AMENDMENT TO THE DRAWINGS

FLASHLIGHT AND COMBINATION FOR USE IN
ALIGNING FLASHLIGHT LAMP BULBS
INV: A. MAGLICA
DKT: 728256-100/119
ANNOTATED SHEET SHOWING CHANGES

Fig. 6

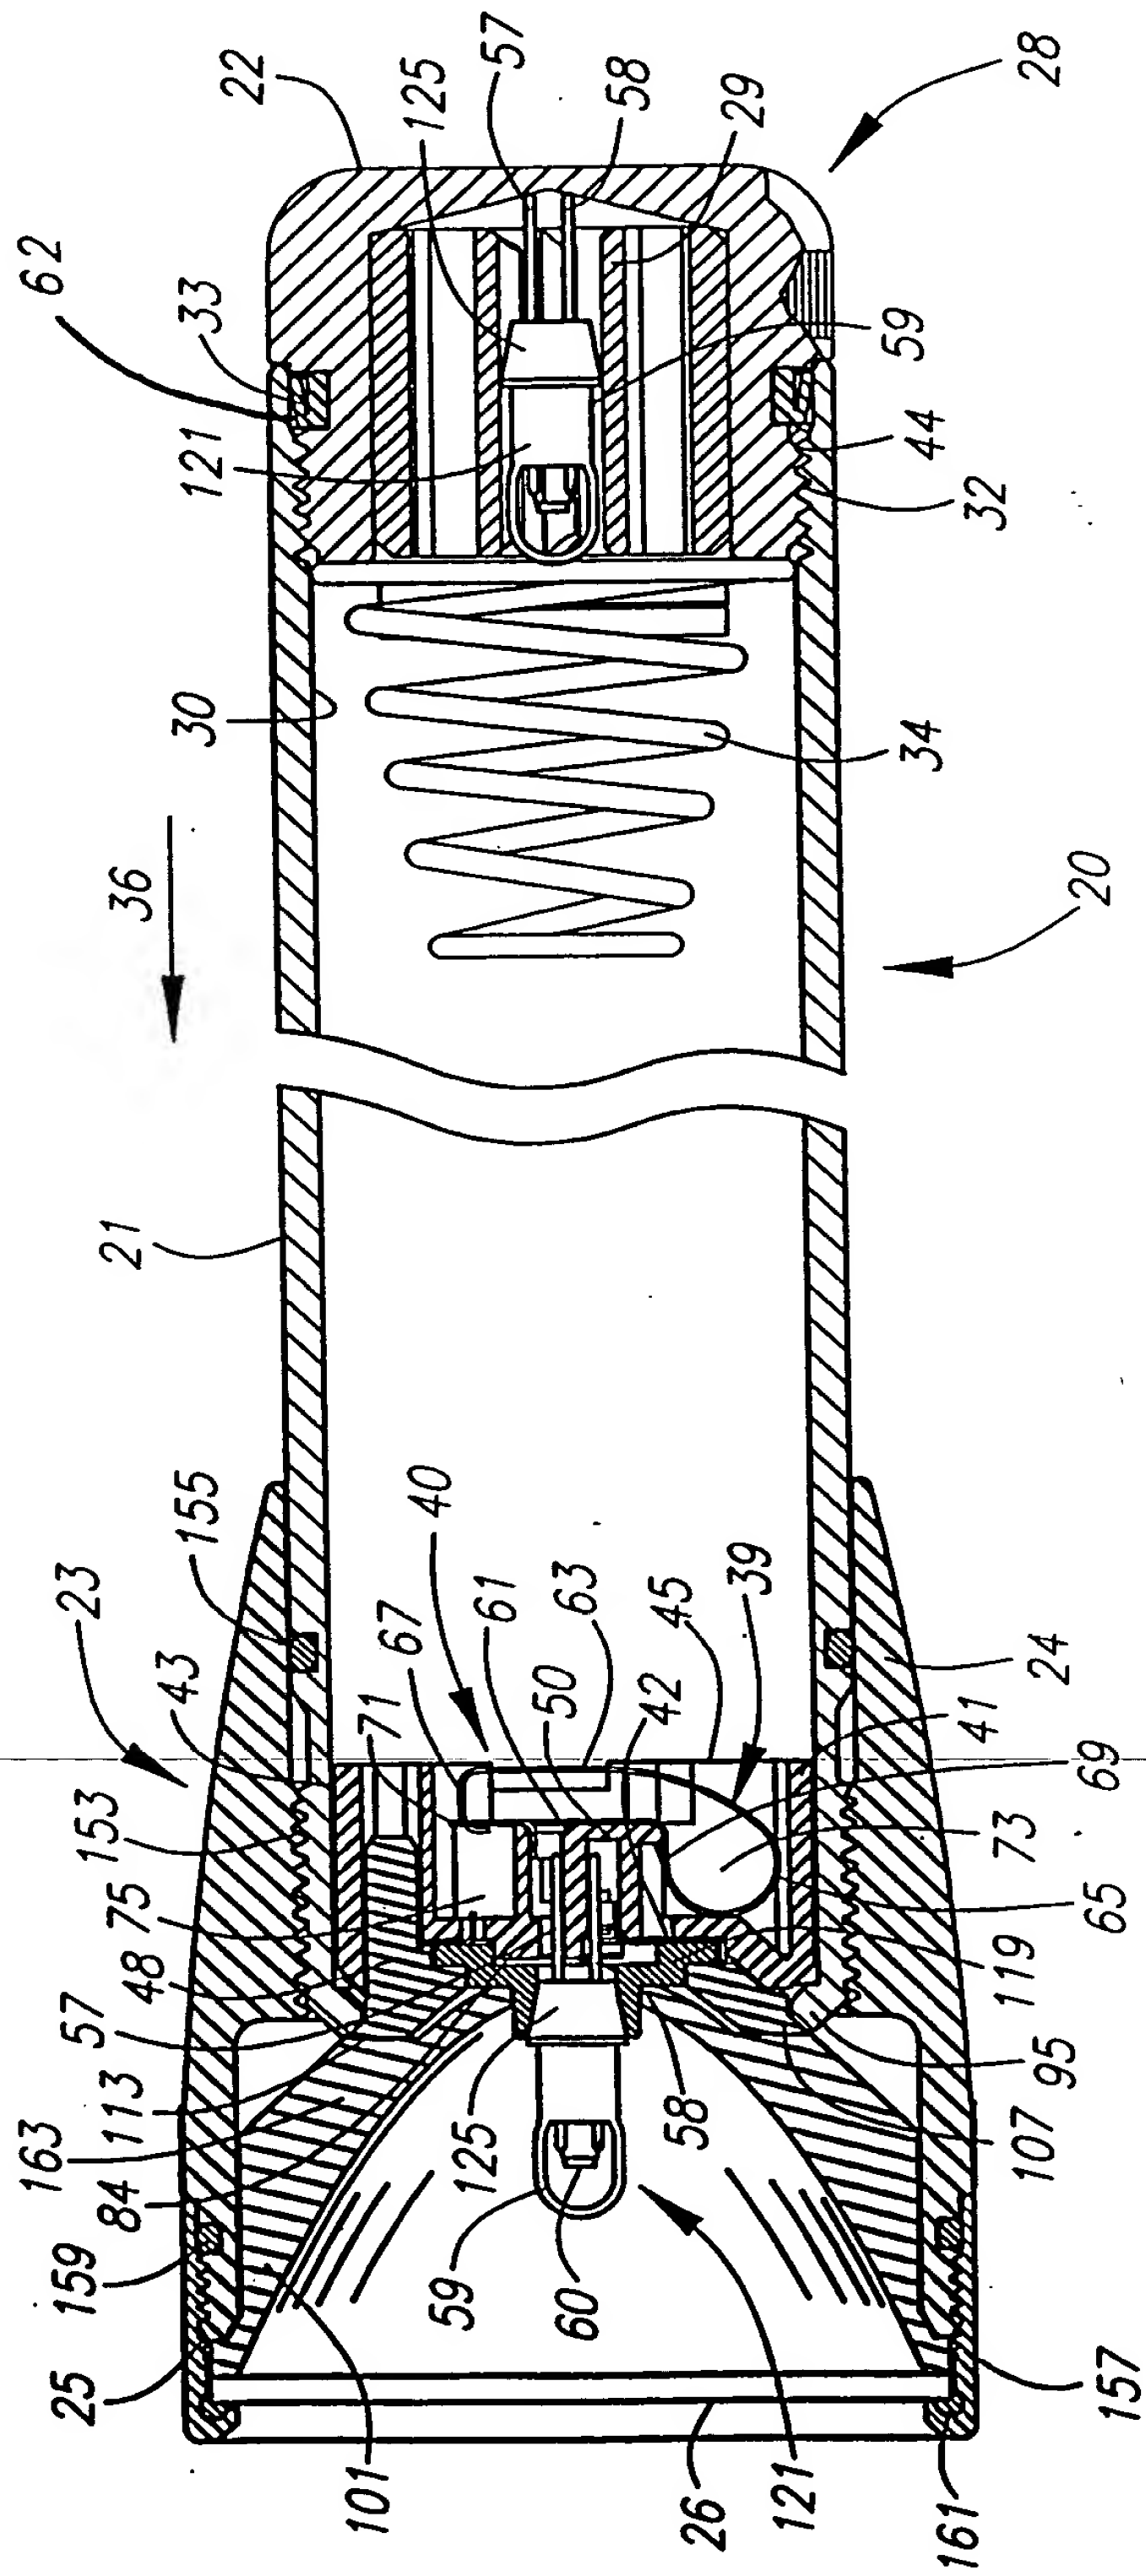
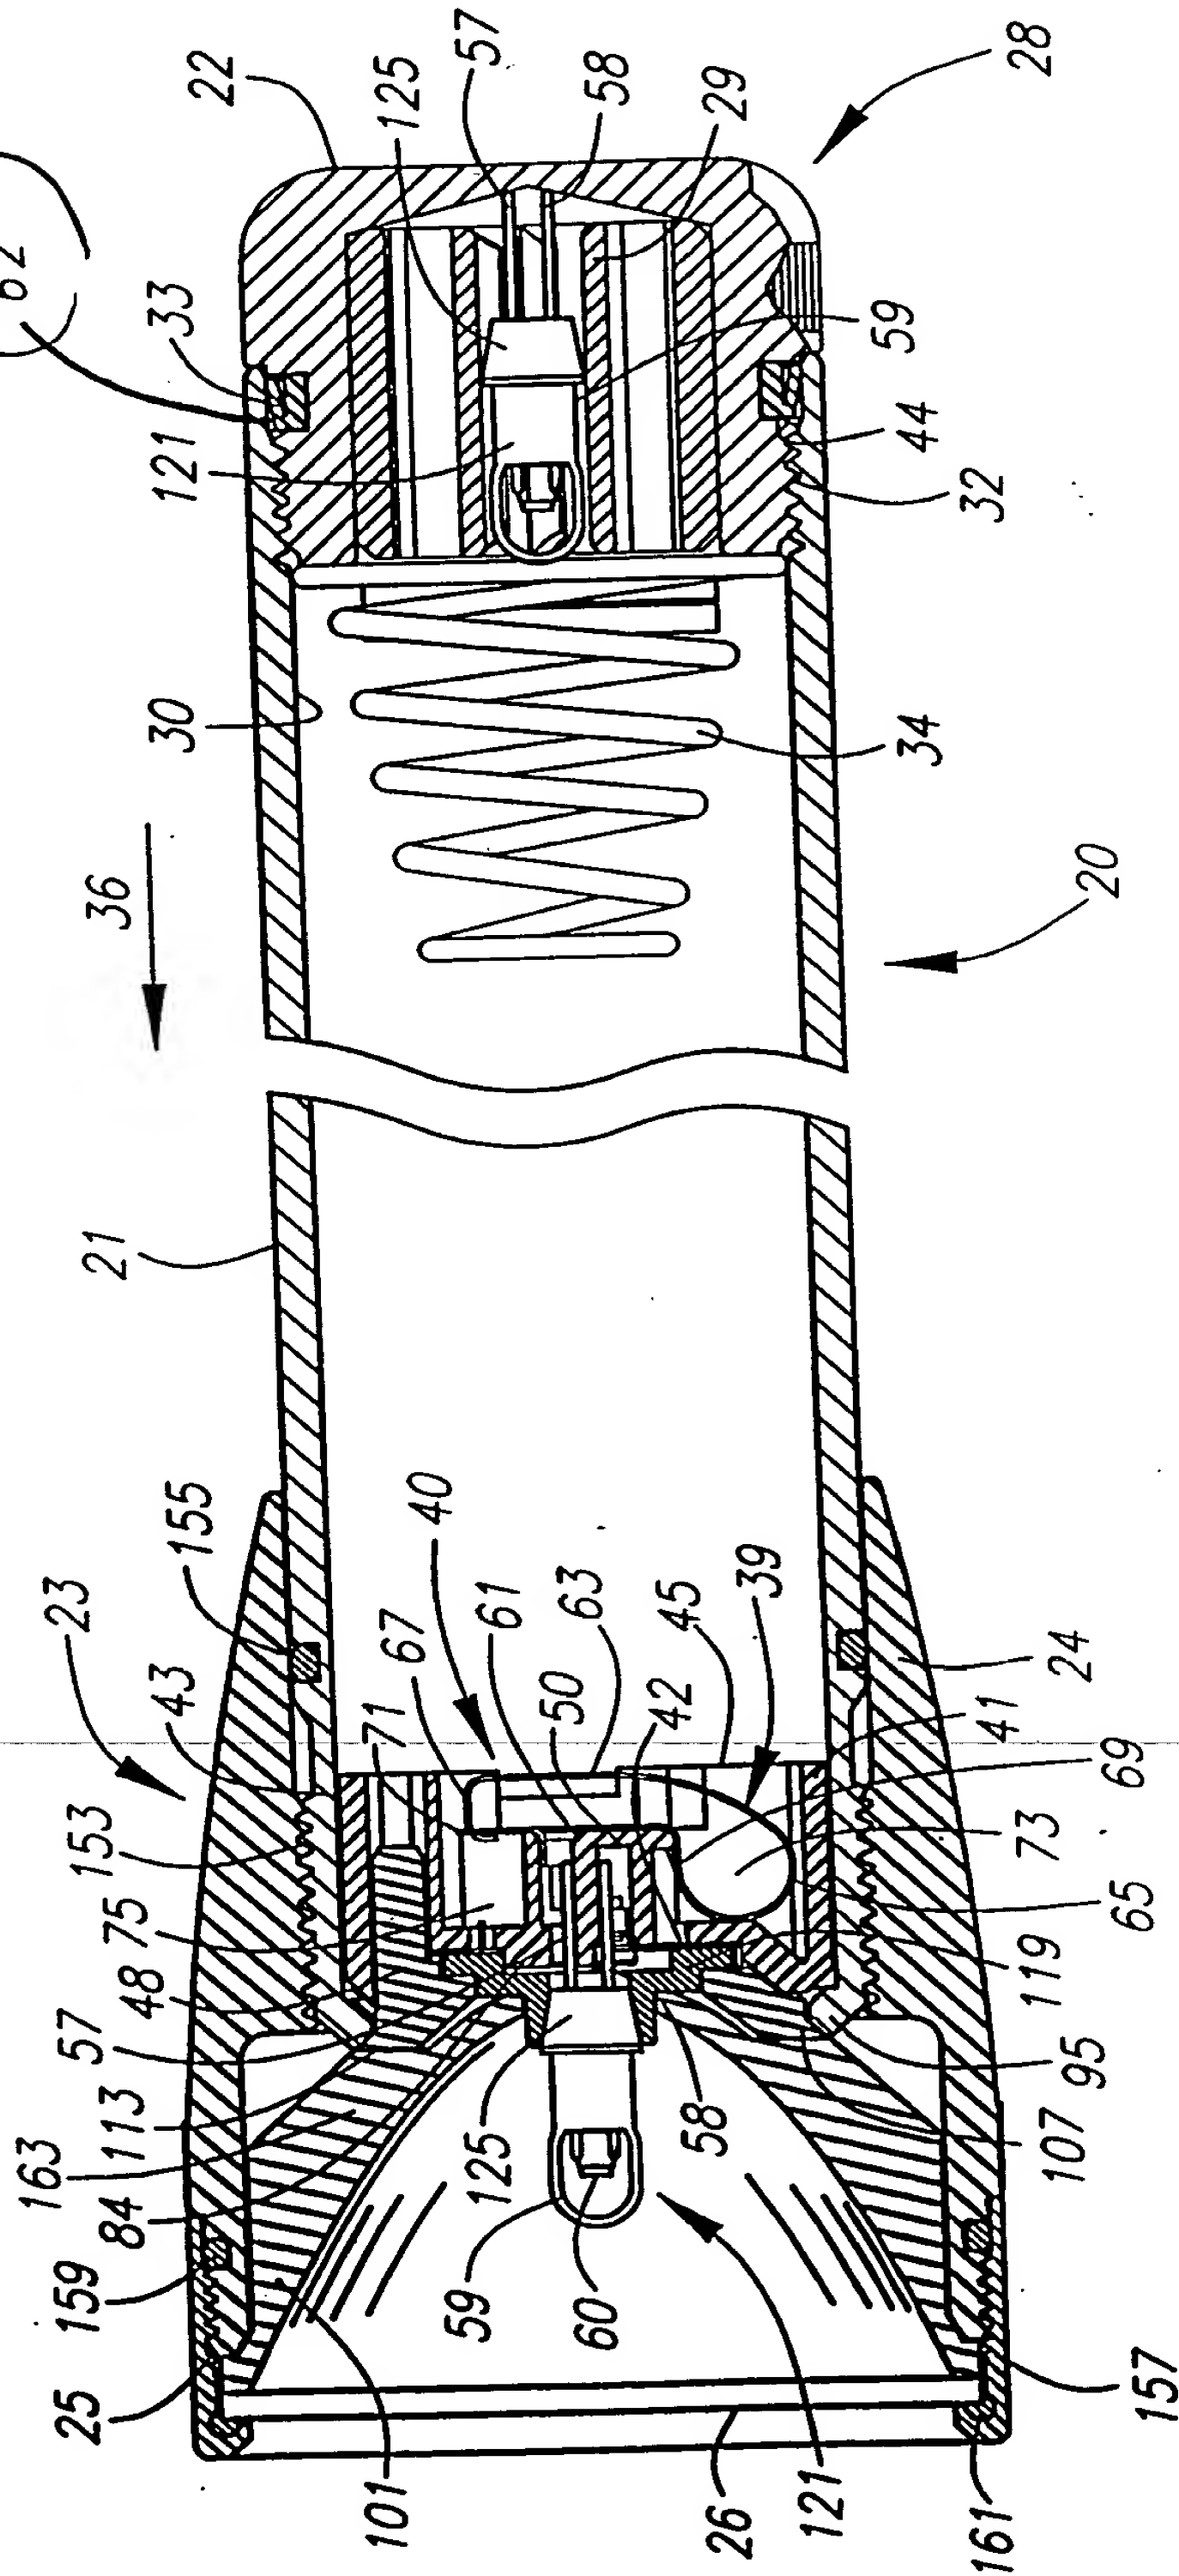
Replacement sheets 02/06, 03/06 and 04/06 replaces original sheets of drawings having the same sheet number. In each of amended Figs. 3, 5 and 6, a new element number character 62 is added to identify the "one way valve" that is disclosed in the body of the specification. The support for this amendment can be found in the specification, for example, at paragraph numbers [0041]. Therefore, no new matter has been added.

*Element
62 added*
